CONSTRUCTION INFRASTRUCTURE DRAWINGS CID-24-04		01	02	03	04	REVISIONS		DATE
TOWN OF ROLESVILLE CID-24-04 V2		01	02	03	04			
TOWN OF ROLESVILLE CID-24-04 V3								
TOWN OF ROLESVILLE CID-24-04 V4								
TOWN OF ROLESVILLE CID-24-04 V5								
TOWN OF ROLESVILLE CID-24-04 V6								
TOWN OF ROLESVILLE CID-24-04 V7								
TOWN OF ROLESVILLE CID-24-04 V8								
TOWN OF ROLESVILLE CID-24-04 V9								
TOWN OF ROLESVILLE CID-24-04 V10								
TOWN OF ROLESVILLE CID-24-04 V11								
TOWN OF ROLESVILLE CID-24-04 V12								
TOWN OF ROLESVILLE CID-24-04 V13								
TOWN OF ROLESVILLE CID-24-04 V14								
TOWN OF ROLESVILLE CID-24-04 V15								
TOWN OF ROLESVILLE CID-24-04 V16								
TOWN OF ROLESVILLE CID-24-04 V17								
TOWN OF ROLESVILLE CID-24-04 V18								
TOWN OF ROLESVILLE CID-24-04 V19								
TOWN OF ROLESVILLE CID-24-04 V20								
TOWN OF ROLESVILLE CID-24-04 V21								
TOWN OF ROLESVILLE CID-24-04 V22

RESERVE @ MITCHELL MILL
TOWN OF ROLESVILLE, WAKE COUNTY, NORTH CAROLINA
CONSTRUCTION PLANS
EROSION CONTROL PLAN OVERALL
PHASE 1 - STAGE 2

STRONG ROCK ENGINEERING GROUP		STRONG ROCK ENGINEERING GROUP, PLLC COMPANY LICENSE # P-2166 305 CHURCH AT NORTH HILLS STREET, SUITE

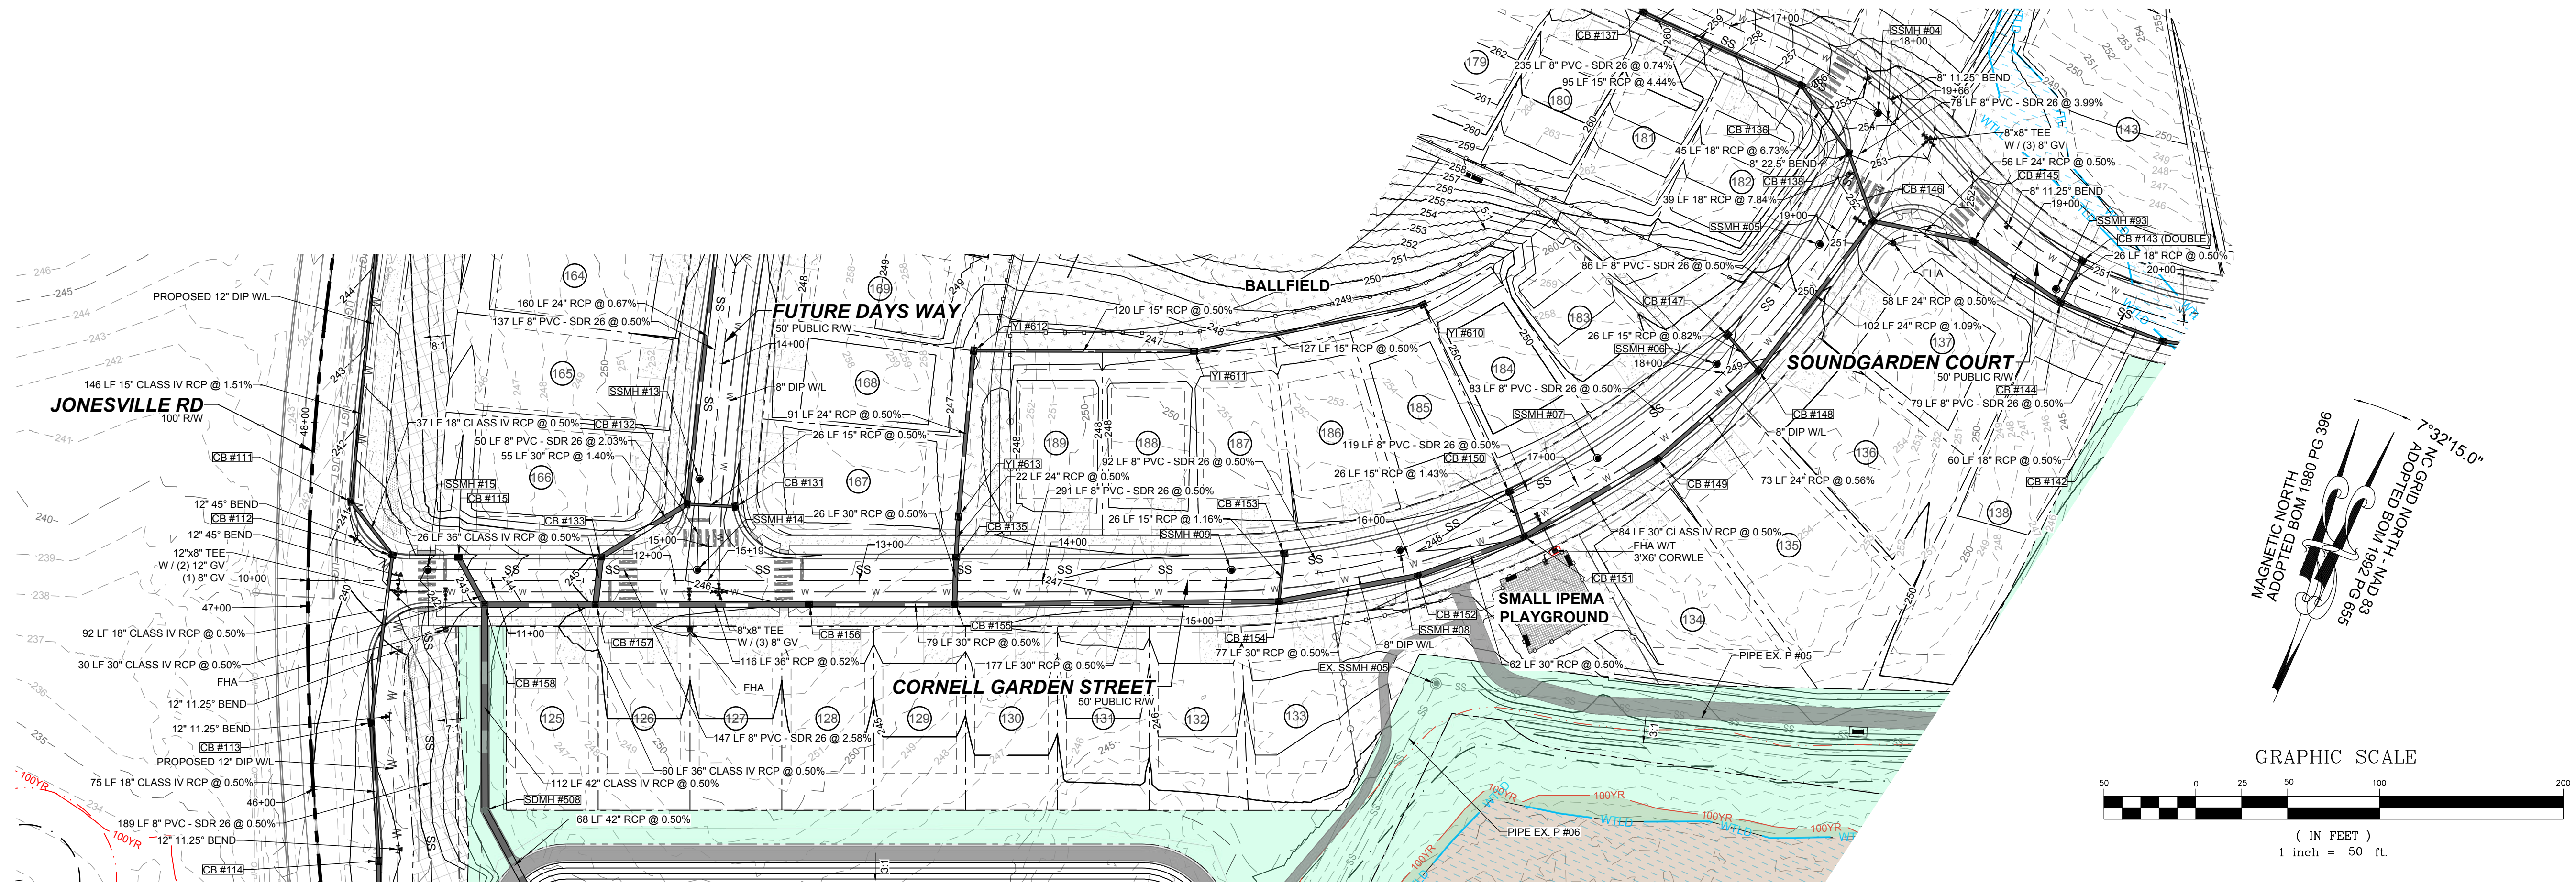
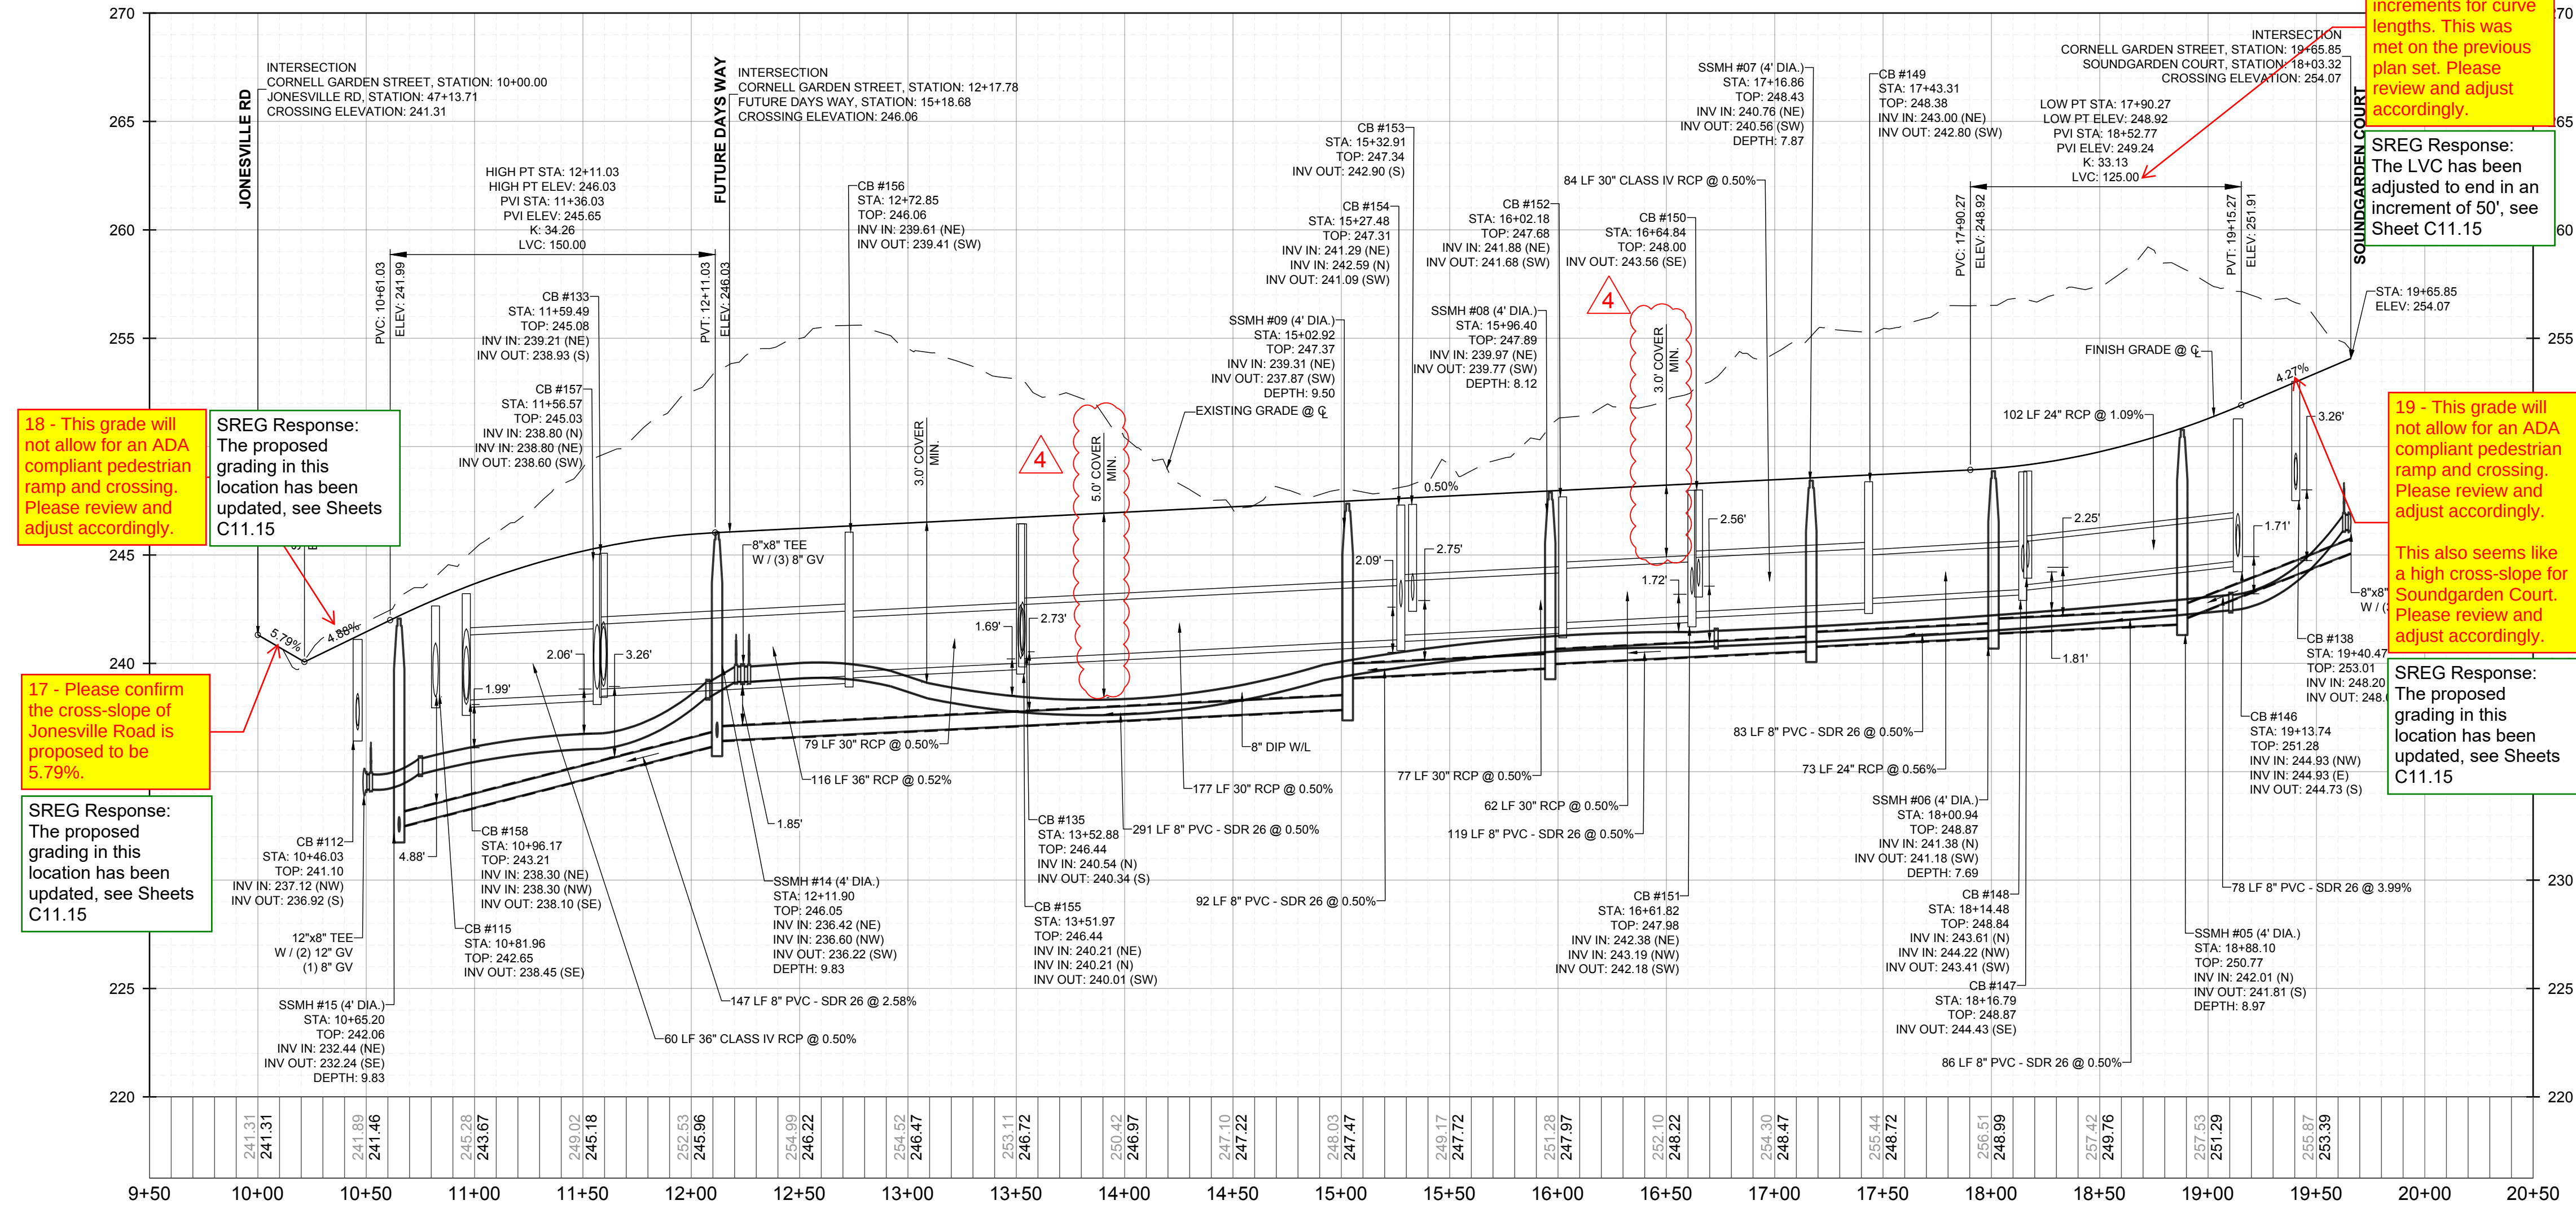
12 - The Town of Rolesville standards call for 50' increments for curve lengths. This was met on the previous plan set. Please review and adjust accordingly.

SREG Response: The proposed grading in this location has been updated, see Sheets C11.15

SREG Response: The proposed grading in this location has been updated, see Sheets C11.15

SREG Response: The LVC has been adjusted to end in an increment of 50', see Sheet C11.15

SREG Response: The proposed grading in this location has been updated, see Sheets C11.15
